Town of Parker Community Development Department
 Development Review Division
 Attention: **Stacey Nerger & Mary Munekata**

Application Type: **Site Plan**
 Status: **First Referral**
 Application Name: **Parker & Pine L3 - Slim Chickens**
 Case/AP#: **SP20-058**
 Referral Received: July 30, 2020
 Comments Due: August 28, 2020

Review date: **August 4, 2020**
 Plan reviewer: **Randall L. Capra, rcapra@parkeronline.org**
 Phone: 303.805.3169

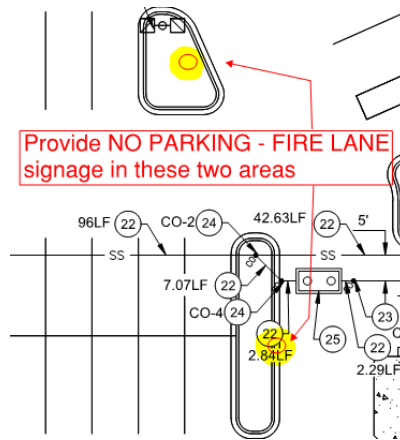
4. Per the requirements of [18 IFC Section 503.1.1 Buildings and Facilities] approved fire apparatus access roads shall be provided for every facility, building, portion of a building hereafter constructed or moved into or within the jurisdiction. The fire apparatus access road shall comply with the requirements of this section and shall extend to within 150 feet of all portions of the facility and all portions of the exterior walls of the first story of the building as measured by an approved route around the exterior of the building or facility (the building is a 155+ feet long and 50.56 feet wide and cannot meet the requirement as measured from the center line of the fire apparatus as measured by an approved route from any point that a fire engine might park when responding to a call at this building). This submittal does not provide for this requirement of the code. Per the requirements of the code, the fire code official is allowed to increase the dimension of the 150 feet provided that the applicant meets Exception 1.1 of this section... "The building is equipped throughout with an approved automatic sprinkler suppression system installed in accordance with section 903.1.1, 903.1.2, or 903.3.1.3. *Satisfied; applicant addressed with current submittal*

Note – With respect to this project, access is provided though occupant loading dictates that the building is to be sprinklered.
